# City of Sierra Madre

## SIERRA MADRE PLANNING COMMISSION MEETING NOTES

Item#2 CUP AMENDMENT 21-19, AND ADDENDUM TO THE MITIGATED NEGATIVE DECLARATION TO UPDATE THE ALVERNO HEIGHTS ACADEMY MASTER PLAN

**ALVERNO HEIGHTS ACADEMY MASTER PLAN UPDATE**  
**NOISE ANALYSIS**  
**200 NORTH MICHILLINDA AVENUE**

Figure 1: Noise Measurement Locations

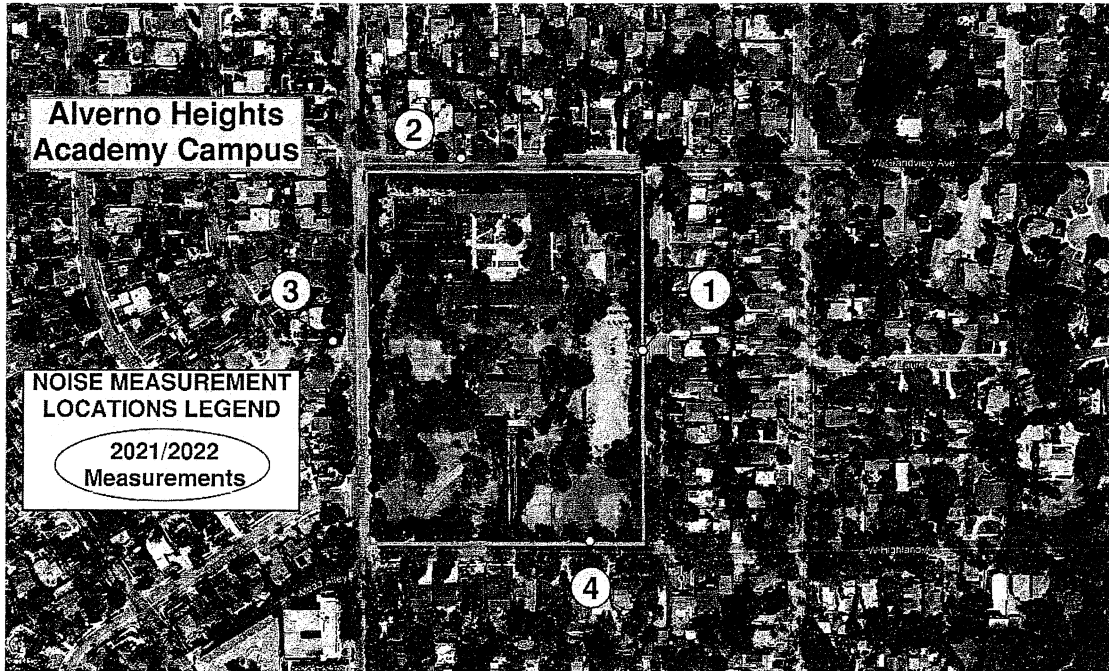
*This presentation slide of the map is incorrect. From CDSA study picture shows the device was on the eastern edge of 693 W Grandview Ave. Not where this slide is marked. Am I wrong? This is WELL OUTSIDE of the plane of the property per the city code. Per Google it's about 100ft.*
